HISTORICAL LANDMARK COMMISSION STAFF REPORT

**Rhode Addition
1205 East South Temple
South Temple Historic District
PLNHLC2010-00031
March 3, 2010**

Attachments:
A. Site Plan
B. Transportation Division
Review
C. Photos

**Attachment A
Site Plan**

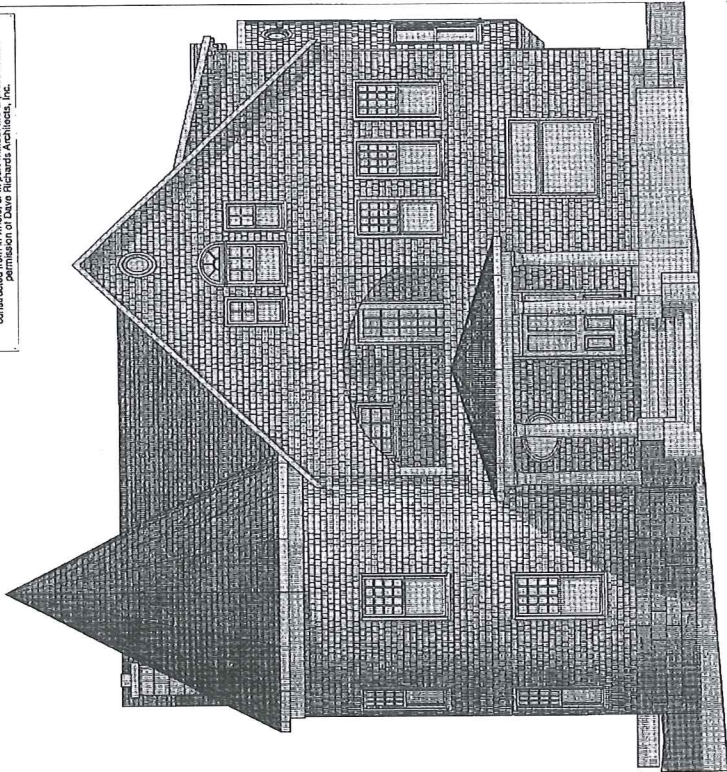
1. The proposed vehicular gate should maintain a 17.5 foot setback from the back of the sidewalk.
2. The driveway grade should change from 8% (as shown on the site plan) to 6% grade.
3. The landscape vegetation within the 10 feet x 10 feet CSZ (clear sight zone) should maintain a maximum height of 30 inches.

The gate show on sheet 2, needs to maintain a 17.5 foot setback form the back of walk.
We recommend a grade revision on sheet 2 from the 8% plus driveway shown to a grade of 6%.
The vegetation (sheet 5) within the 10x10 CSZ needs to maintain a maximum height of 30 inches.
